NINE MILE POINT NUCLEAR STATION UNIT 1

Amendment No. 5
License No. DPR-17

ATTACHMENT TO LICENSE AMENDMENT NO. 5
CHANGE NO. 13 TO TECHNICAL SPECIFICATIONS
FACILITY OPERATING LICENSE NO. DPR-17

SAFETY EVALUATION BY THE DIRECTORATE OF LICENSING
SUPPORTING AMENDMENT NO. 5 TO LICENSE NO. DPR-17
(CHANGE NO. 13 TO THE TECHNICAL SPECIFICATIONS)

FIGURE 6.1.2
NMP-JAP NUCLEAR SITE
OPERATION ORGANIZATION

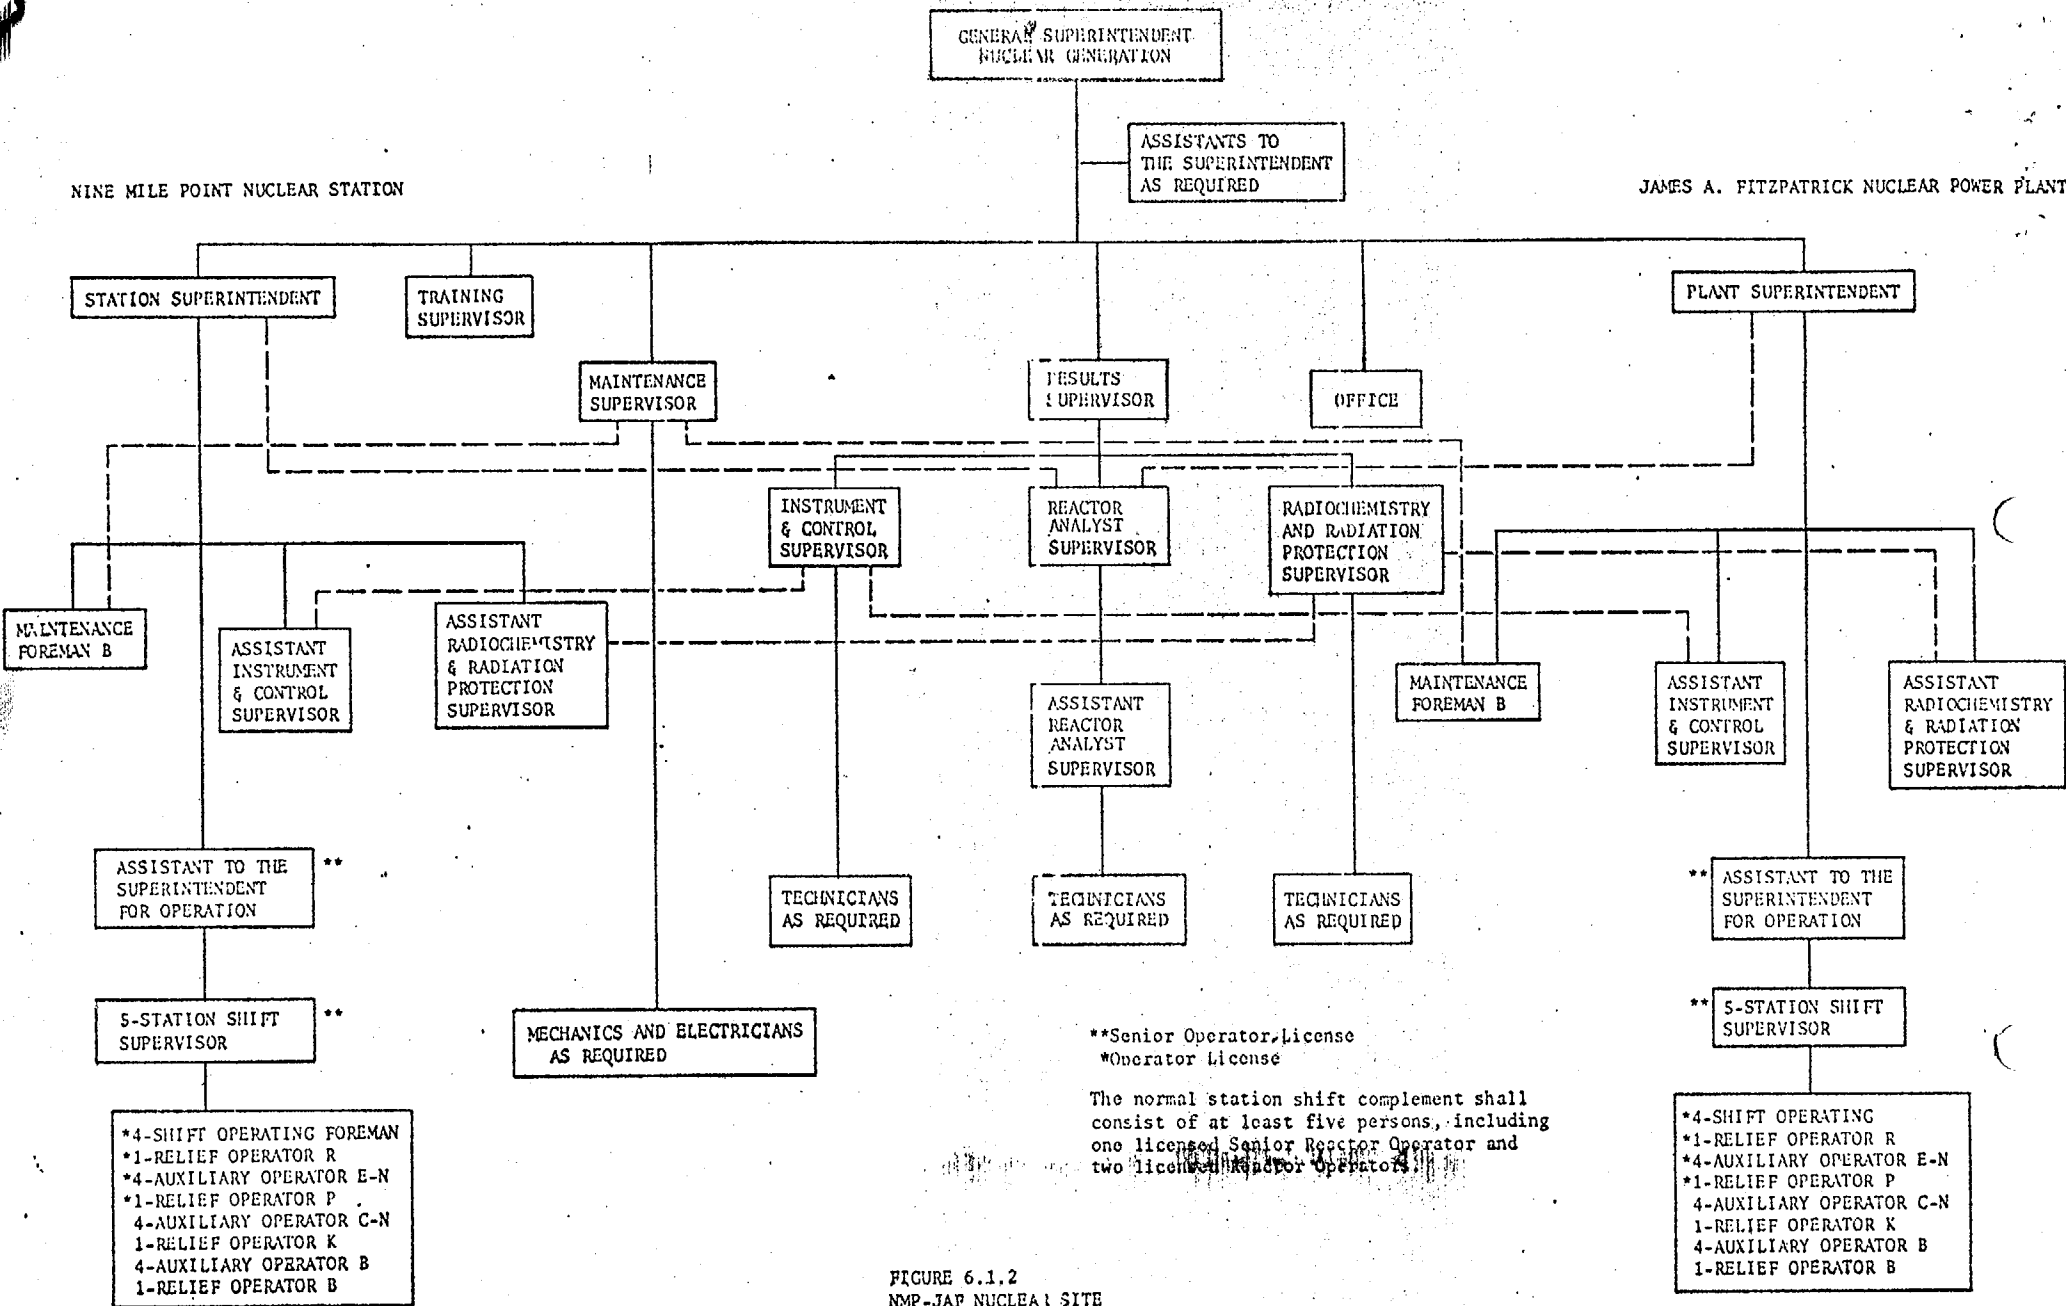
The proposed change involves a rearrangement of the office staff which presently reports to the Results Supervisor to report directly to the General Superintendent. The licensee states that the workloads of both the office staff and the results staff have increased since the initial operation of NMP-1. To allow for better distribution of the supervisory workload, the licensee further states, it is proposed that the office staff with its own supervision report directly to the General Superintendent. The proposed change was reviewed and approved by the licensee's Site Operations Review Committee and by the Safety Review and Audit Board.

We have reviewed the proposed change and note that with the present arrangement the office staff reports indirectly to the General Superintendent. This reporting is made direct with the proposed change. We have concluded that the proposed change has no effect on safety of operation of NMP-1.

Replace page 119, i.e. Figure 6.1.2, with the attached revised page.
